**Historic Landmark Commission
February 27, 2012
Certificate of Appropriateness
LHD-2011-0025
307 W. 45th Street
Hyde Park Local Historic District**

Relocate the existing house on the lot to a 50 foot set back and demolish an existing detached garage structure.

Proposed site plan with location of heritage trees indicated

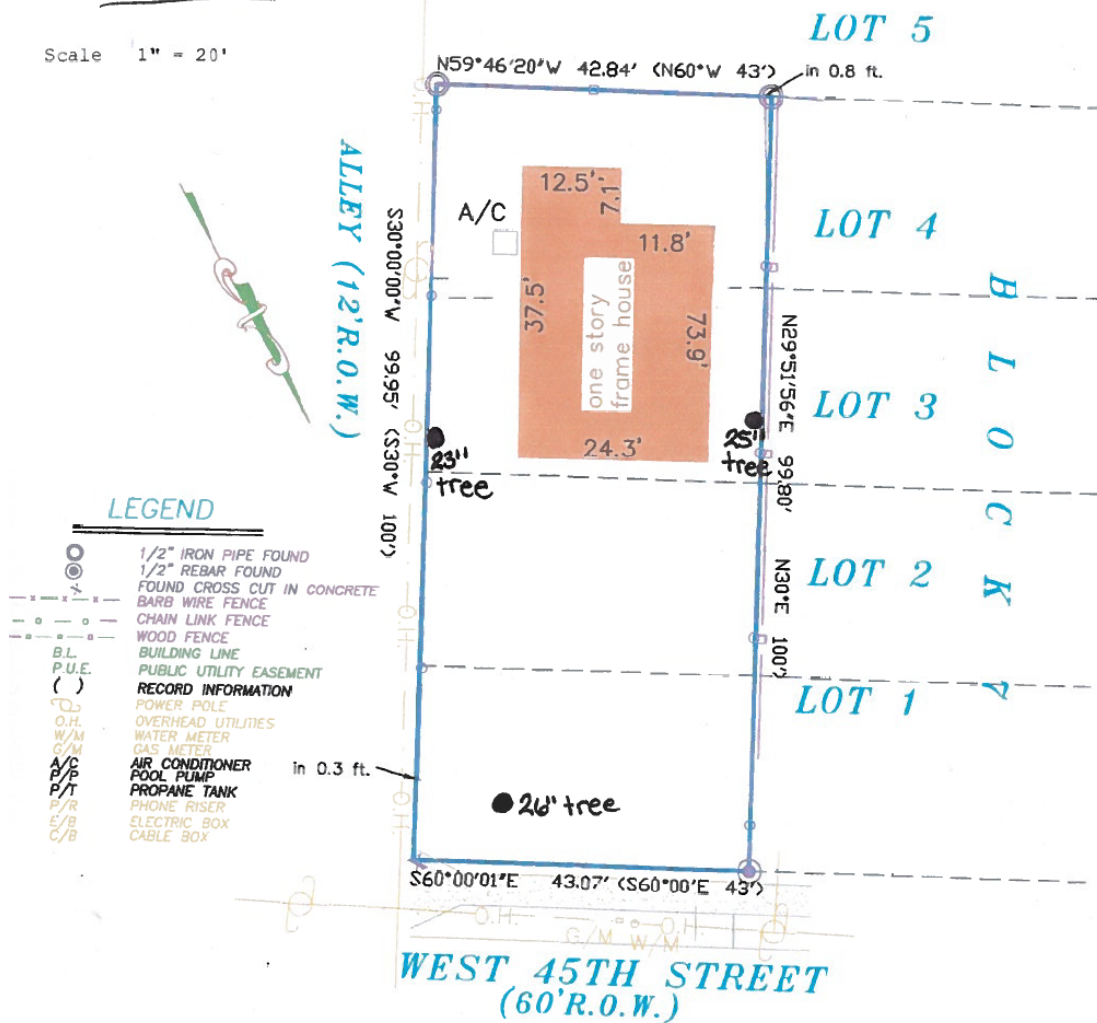
The applicant proposes to relocate the house to the rear of the property with a 50 foot set back from the sidewalk. The applicant further proposed to demolish the existing detached garage to accommodate the new location of the house, and to maintain the existing location of the driveway along the side of the house.

Staff recommends approving relocation of the house with a maximum setback of 30 feet from the sidewalk, maintaining the location of the driveway running along side the house. Staff further recommends approving the demolition of the existing detached garage.
